Addendum to:

Series 988 Family

1/8 DIN Microprocessor-Based
Temperature/Process Controllers

Addendum to:
Series 988 Users Manual - 0600-0009-0001 Rev W
Series 982 Users Manual - 0600-0009-0008 Rev N
Series 98LF Users Manual - 0600-0009-0000 Rev A
Series 998 Users Manual - 0600-0010-0000 Rev F
June, 1999

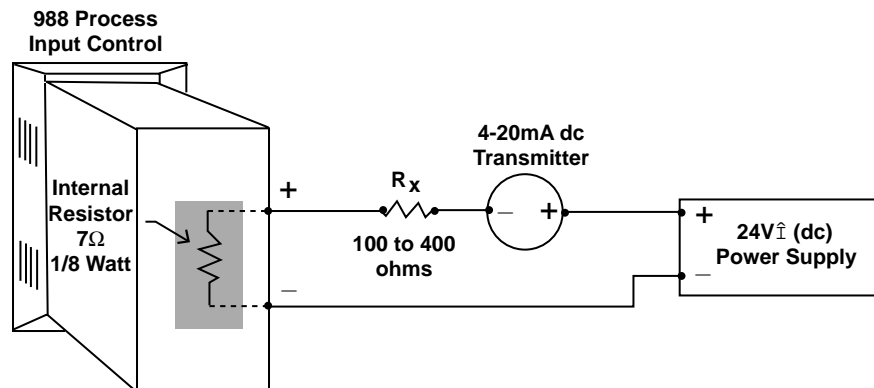
Certain "transmitters" used in process input applications are producing internal resistor failures in the Watlow Series 988 family of controllers. This is only apparent with the Series 988 family 1/8 DIN units with Process Inputs selected (0-20mA or 4-20mA dc only).

We are noticing that an external resistor is required to prevent a high in-rush current which burns out the Series 988 family controllers' 7-ohm internal resistor. This high in-rush current occurs initially on "power-up." If the transmitter turns full on for a split second during power-up, the available current weakens or damages the internal resistor.

Example: $20V / 7 \text{ ohms} = 2,857\text{mA}$ (too much!).

The wiring diagram example below shows an application where a customer is using a 4-20mA dc transmitter and power supply to feed the input of a Series 988 controller. The Rx range (100 to 400 ohms) for the external resistor is recommended. We suggest starting with 250 ohms.

Example: Customer is using a 24V $\hat{=}$ (dc) power supply to power up the 4-20mA dc transmitter that inputs to the Series 988 terminals 8 (-) and 10 (+). To figure out what the internal Series 988's handling current is for the 0-20mA or 4-20mA dc input to the Series 988 controllers, we need to apply Ohm's Law: The square root of Watts divided by Resistance equals Current. Applying that formula to the example below produces the following: Square Root of (0.125 Watts / 7 ohms) = 134 mA dc (handling input current). This is the acceptable input current for the Series 988 universal input board.

Reminder, the input impedance of 7 ohms handles the majority of our customer applications; the external resistor (Rx) is only for certain transducers/transmitters that spike on power-up or power-down. Please make sure your customer's transmitter / transducer fall within our Series 988 family (1/8 DIN) of controllers' Process Input specification of 7 ohms input impedance.
